MARINO ENGINEERING ASSOCIATES, INC.

January 23, 2017

Re: Brook Mine Permit Application

FIGURE 4.2 PROPOSED MINE PLAN (SEE EXHIBIT MP.15-1)

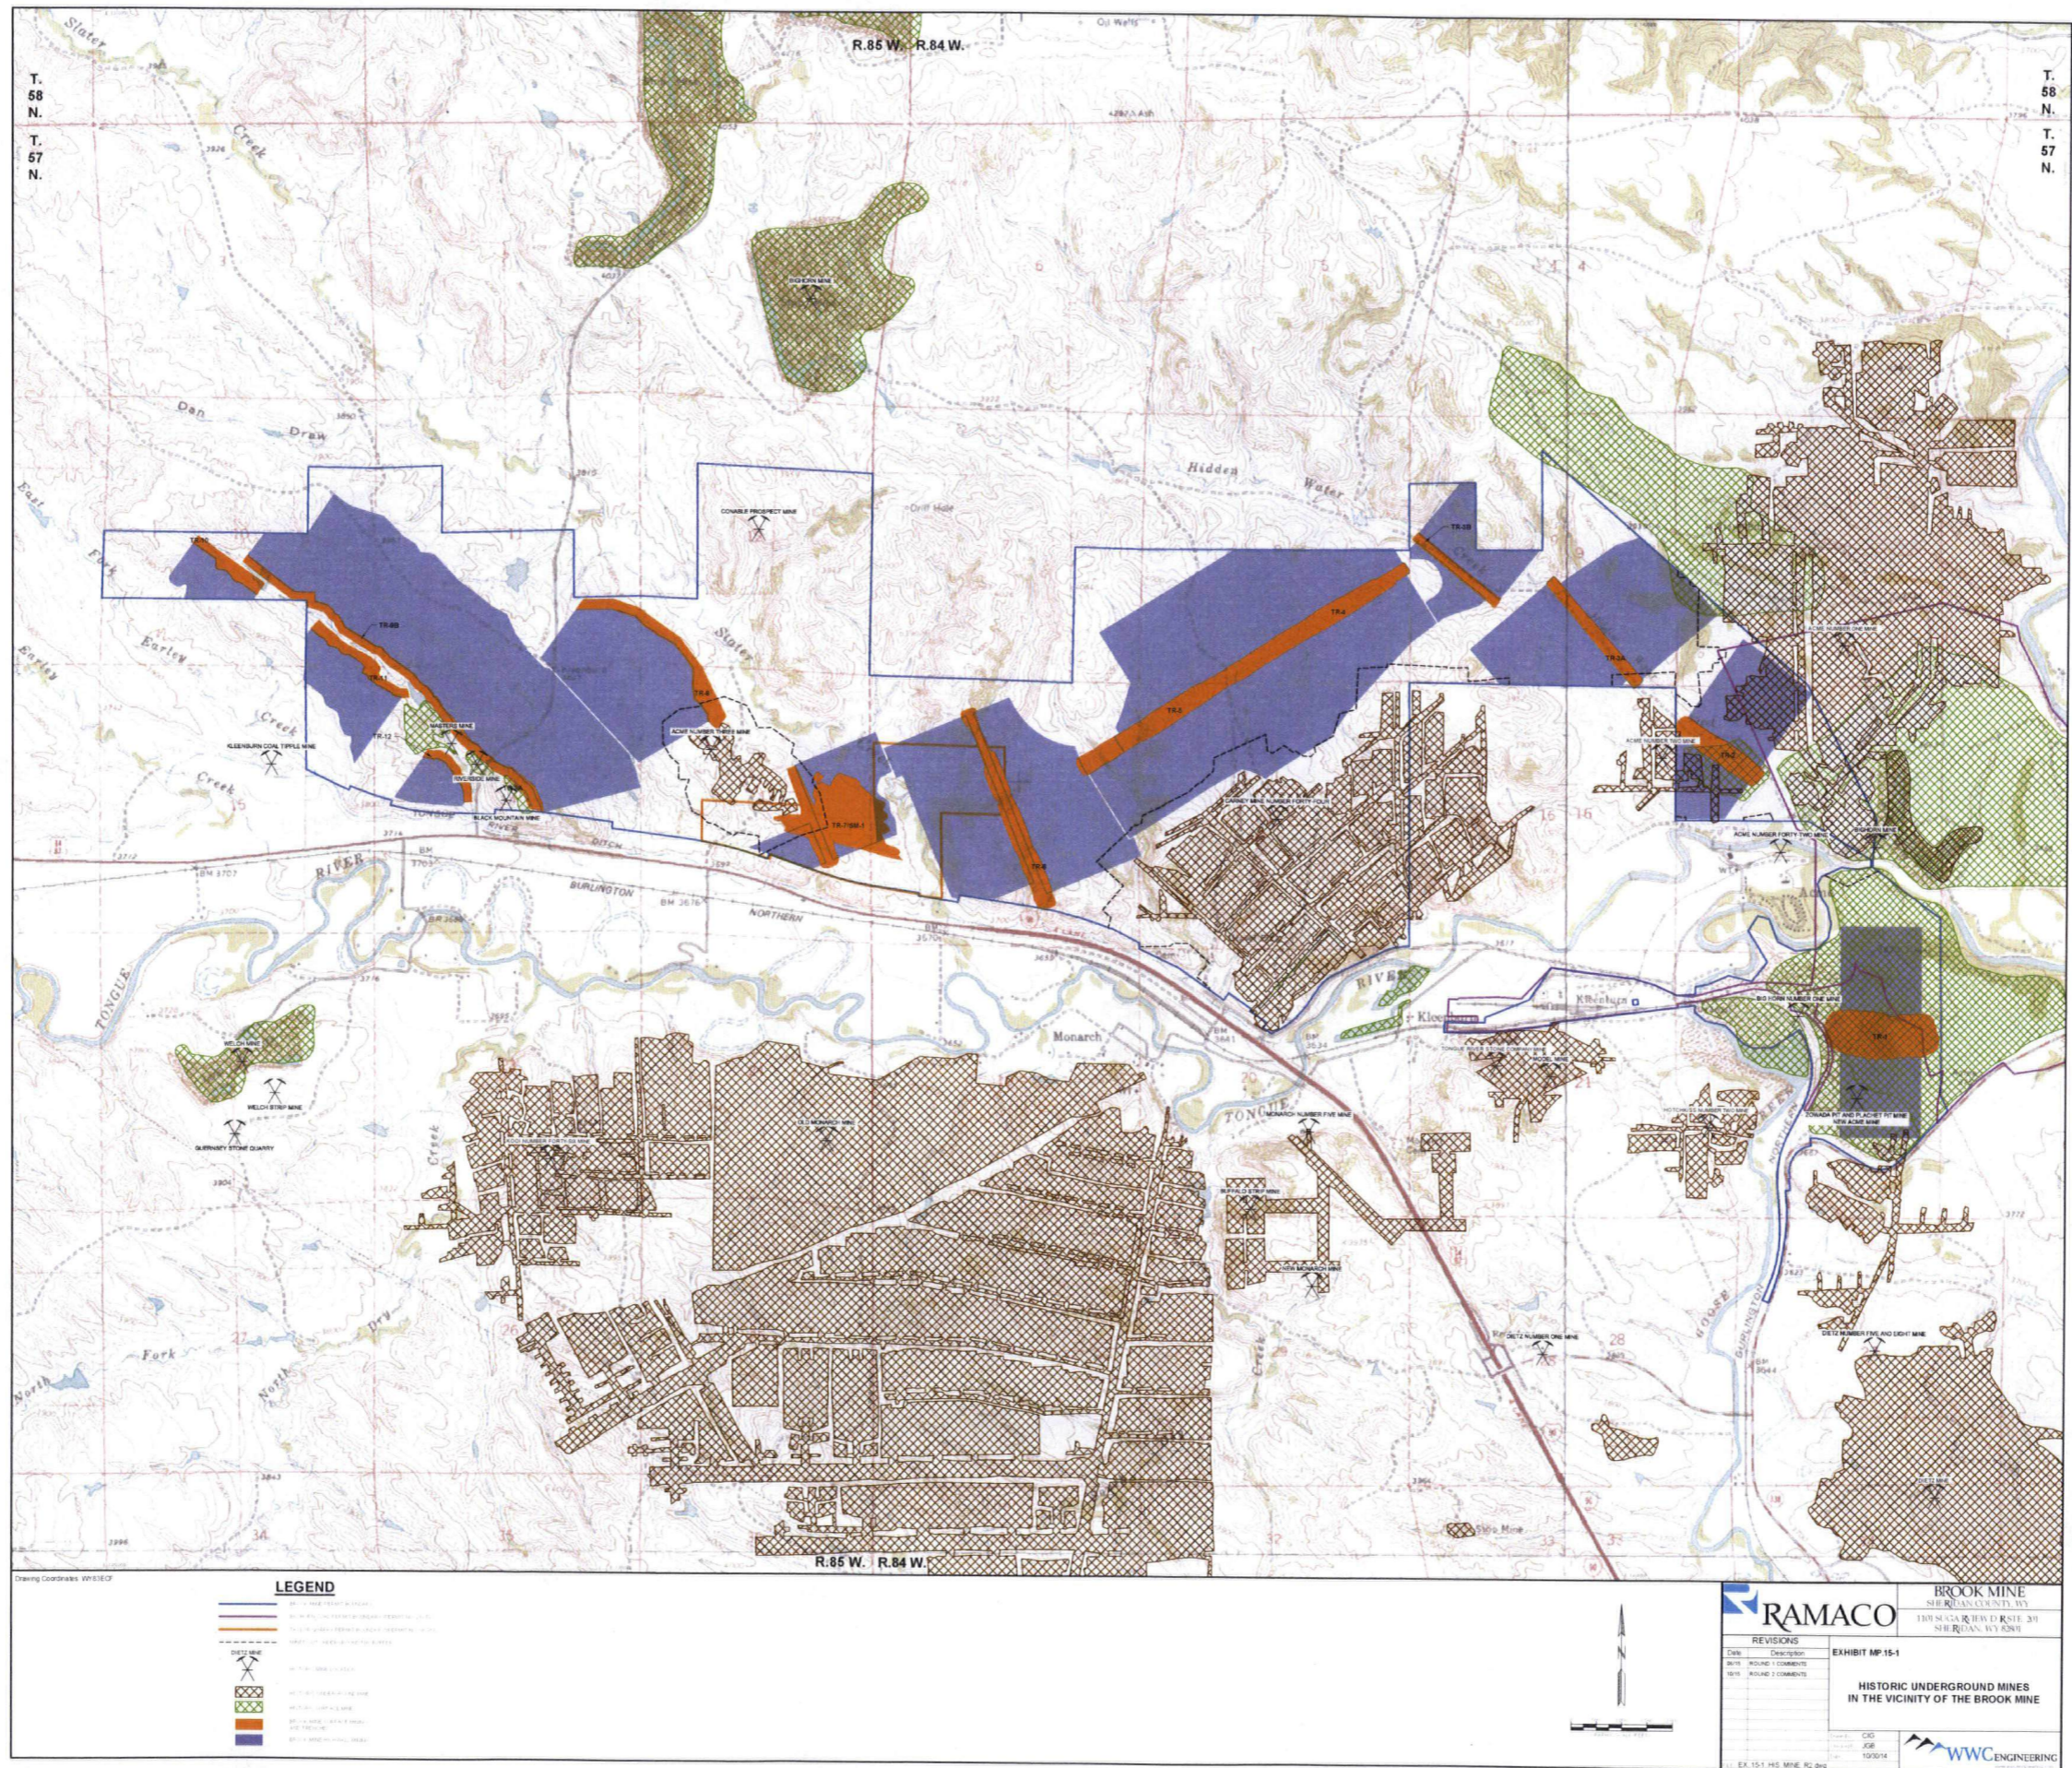
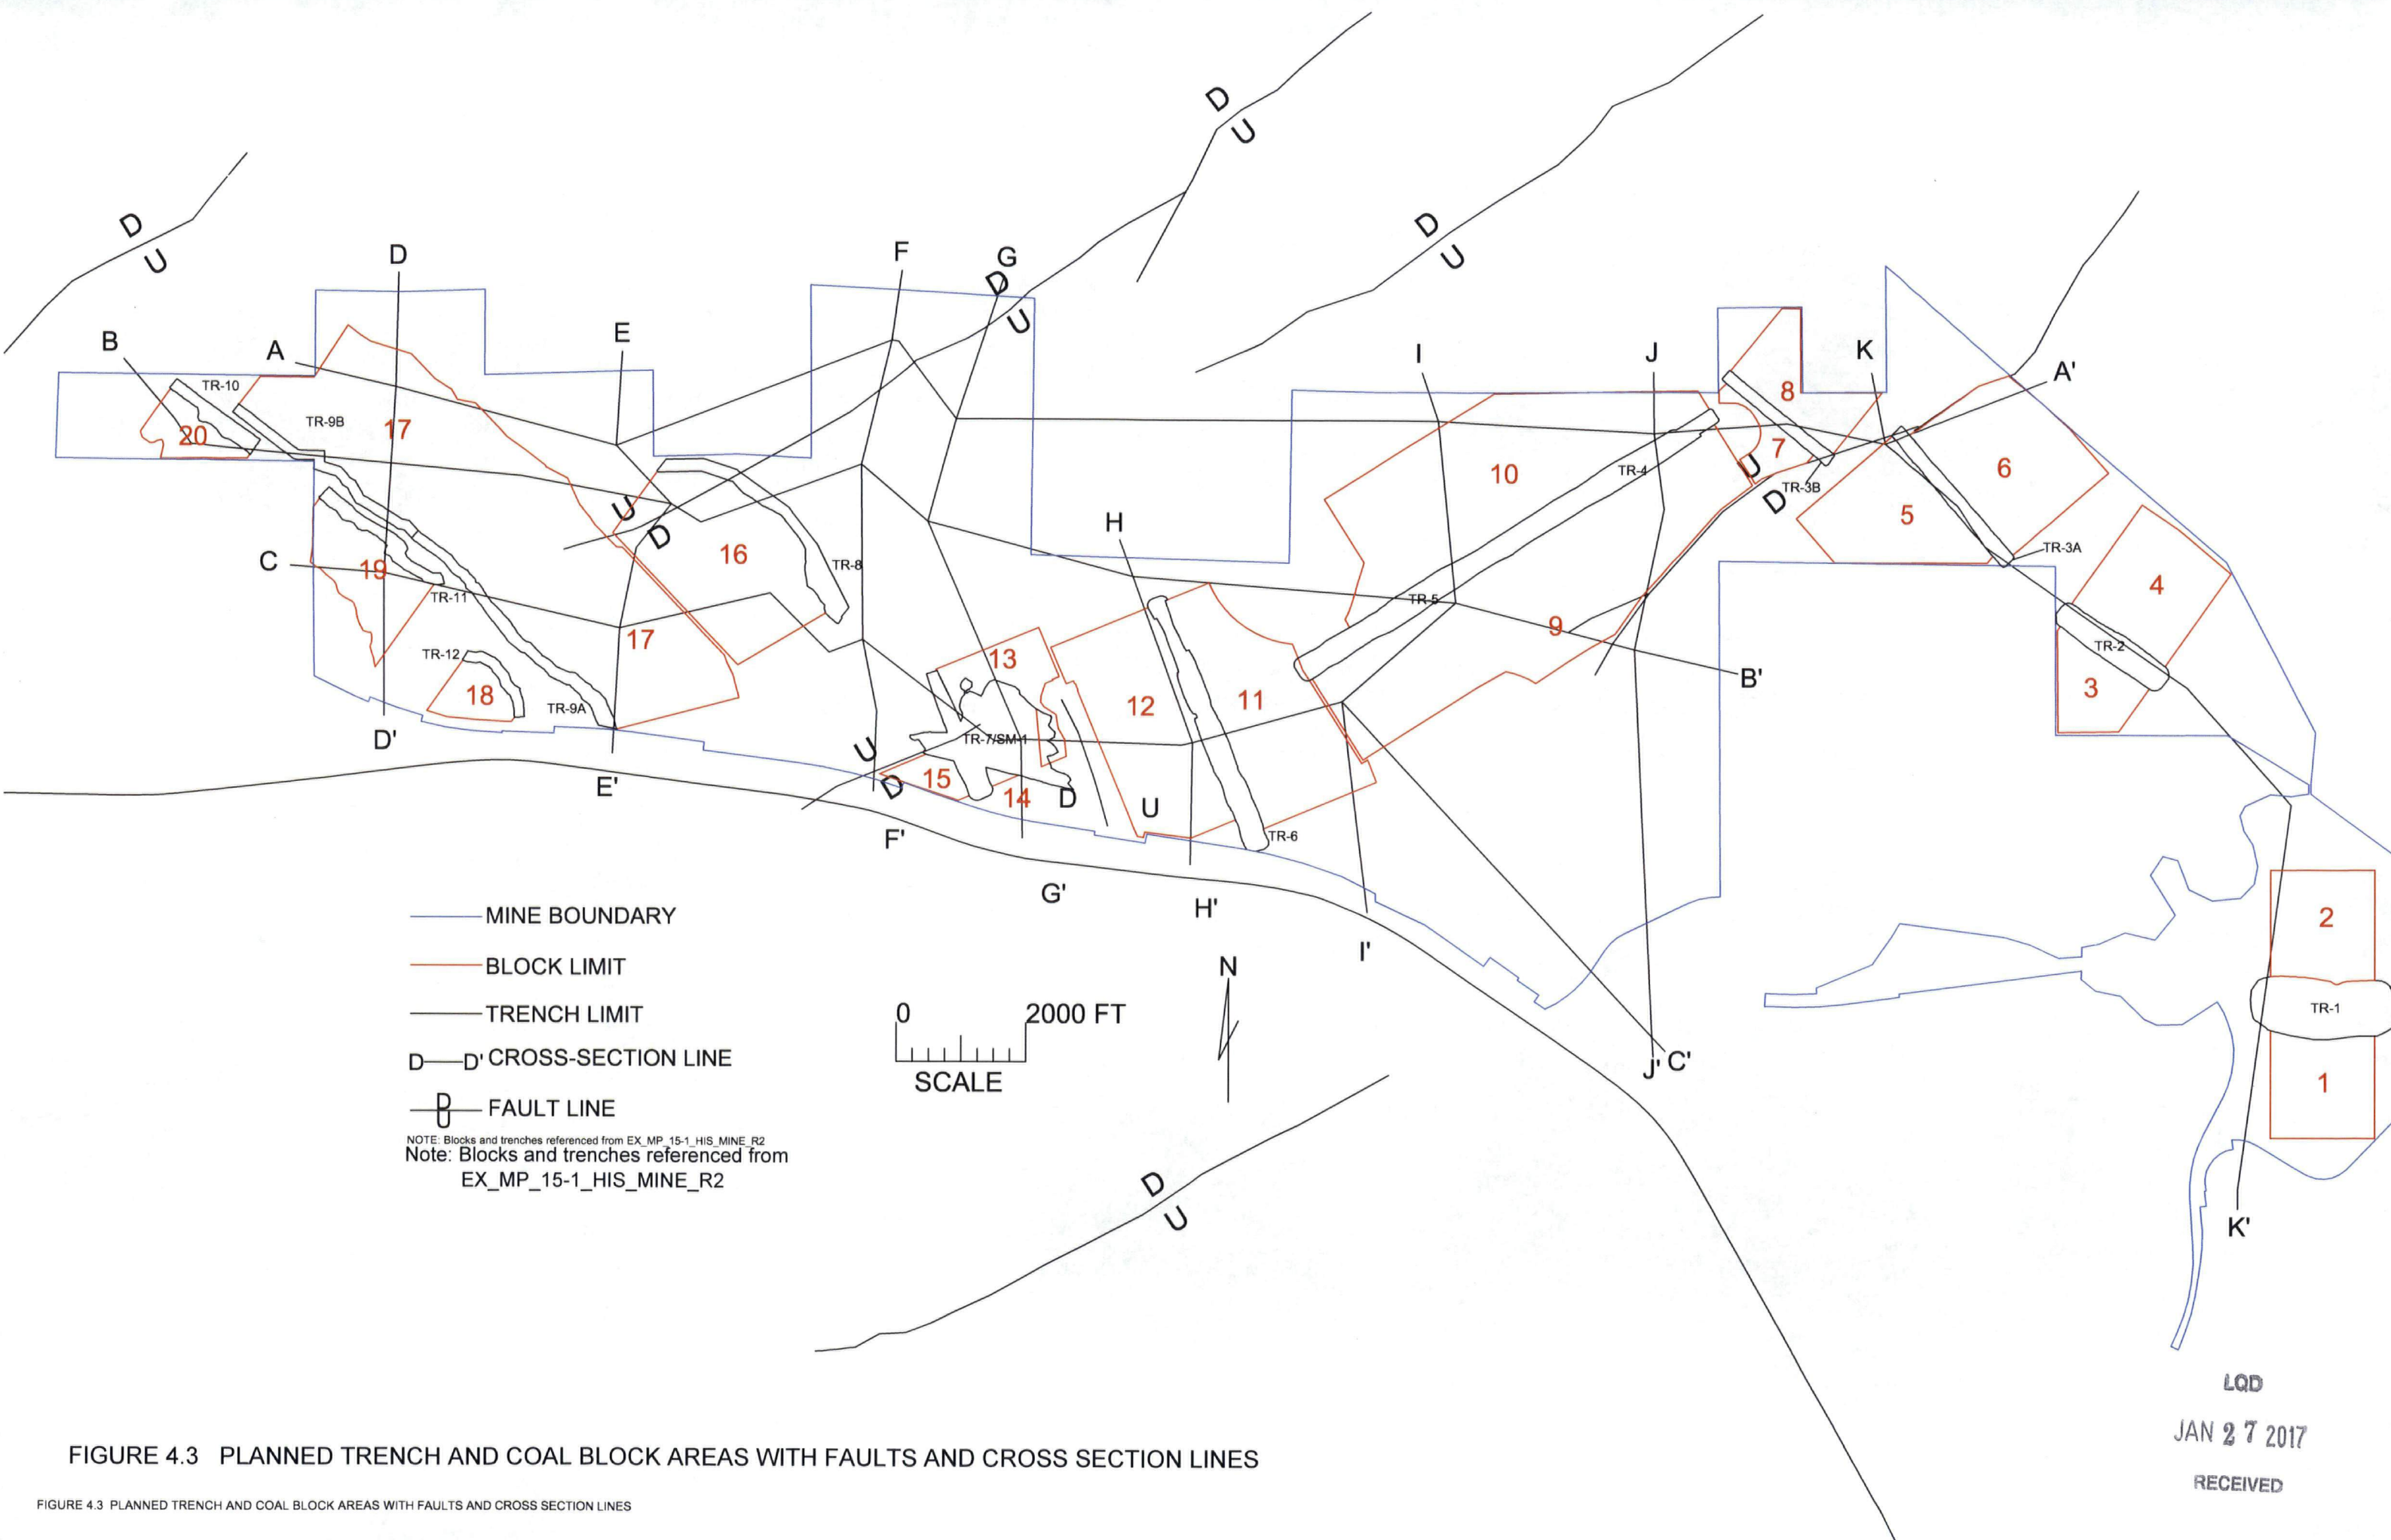
The plan showing the areas of proposed mining are depicted in Figure 4.2. This plan shows the blocks of highwall mining and associated strip mining areas. In Figure 4.3,

FIGURE 4.3 PLANNED TRENCH AND COAL BLOCK AREAS WITH FAULTS AND CROSS SECTION LINES

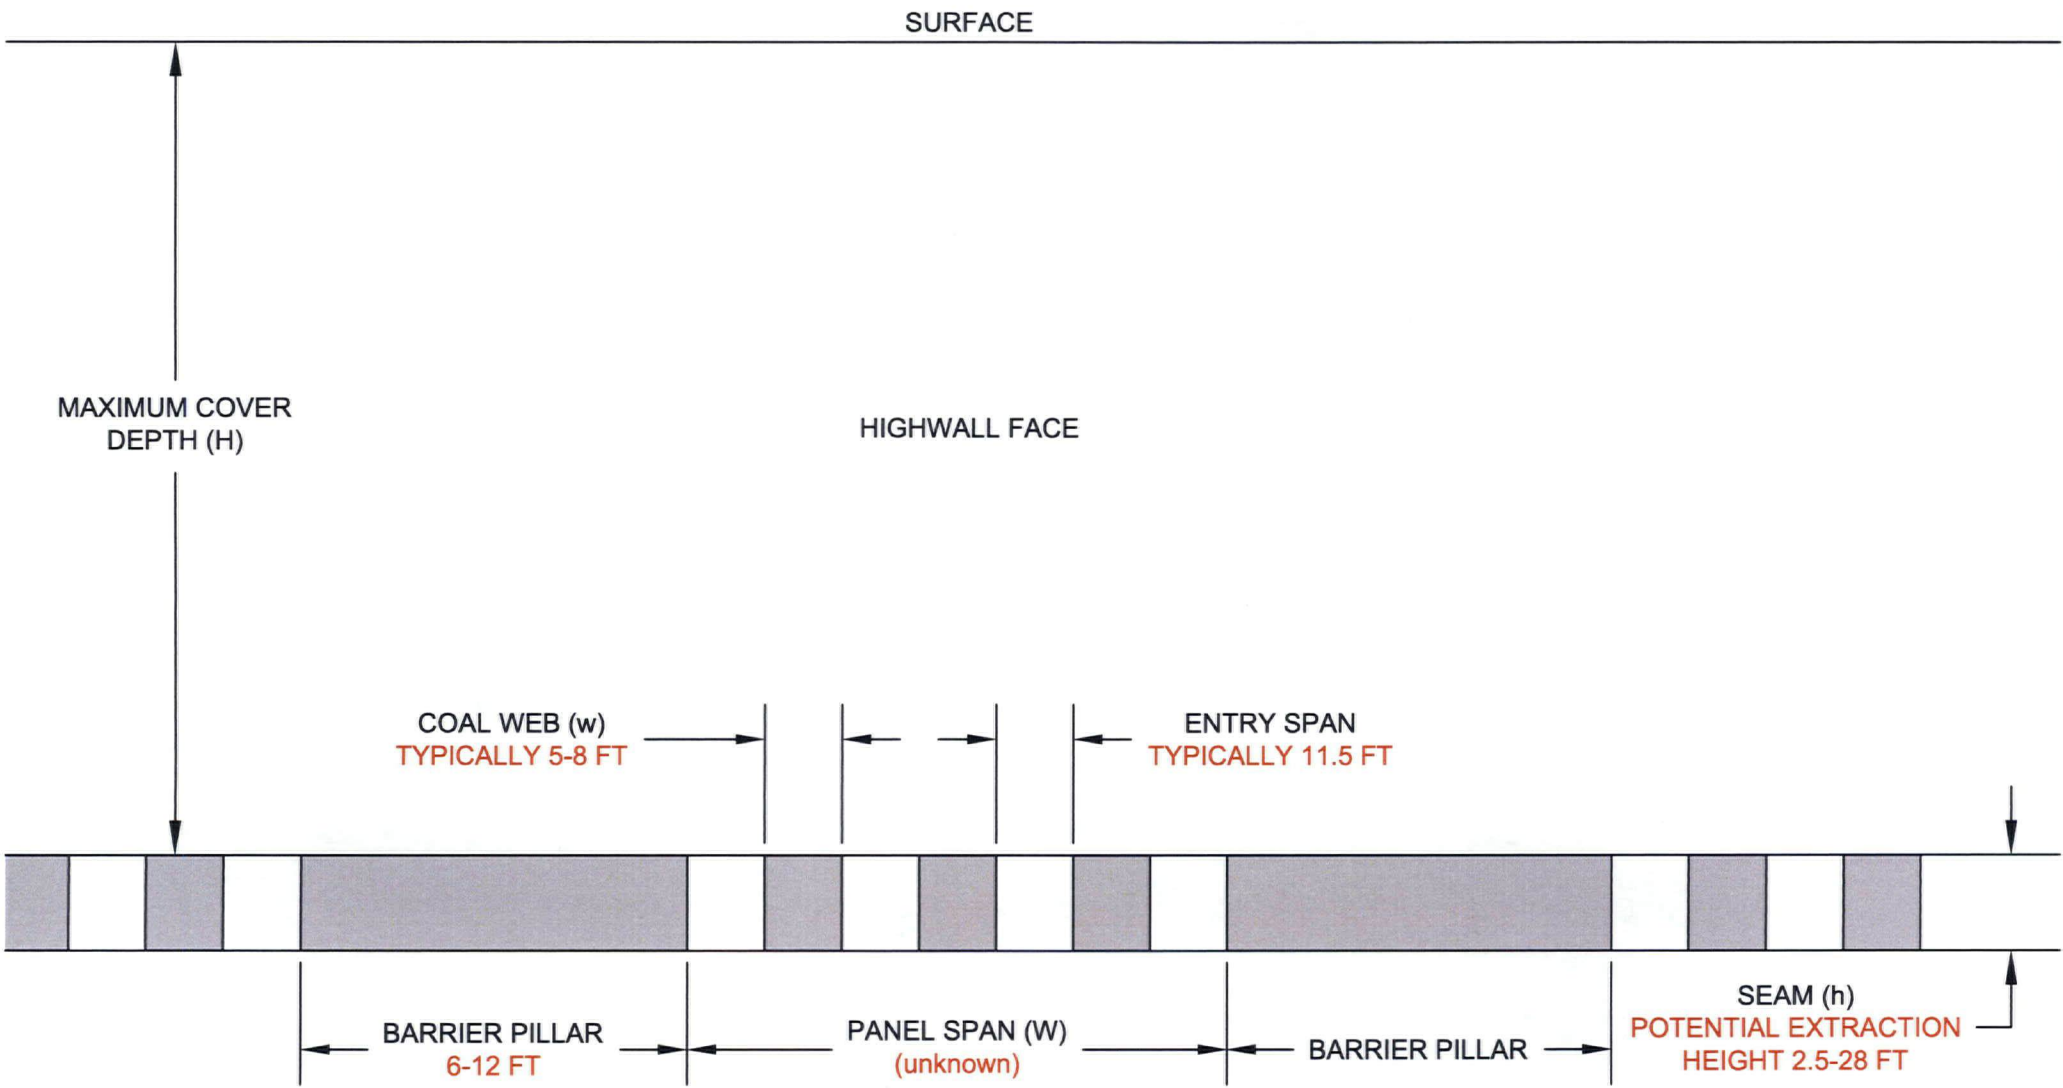
The proposed room and pillar configuration is depicted in Figure 4.4. As can be seen in Figure 4.4, there is no definitive geometry stipulated in the application as much of the identified dimensions are qualified. Using the "typical" web pillar widths and room width, the panel extraction ratio would vary from 59% to 70% in the panels.

Ramaco also states that where multiple coal seams will be mined in a block the pillars will be stacked. With apparently the parallel entries of about the same width, this means the pillar width would be the same for all seams of different thickness. Ramaco states the pillar width will be determined by the seam with the greater thicknesses [MP-6-7].
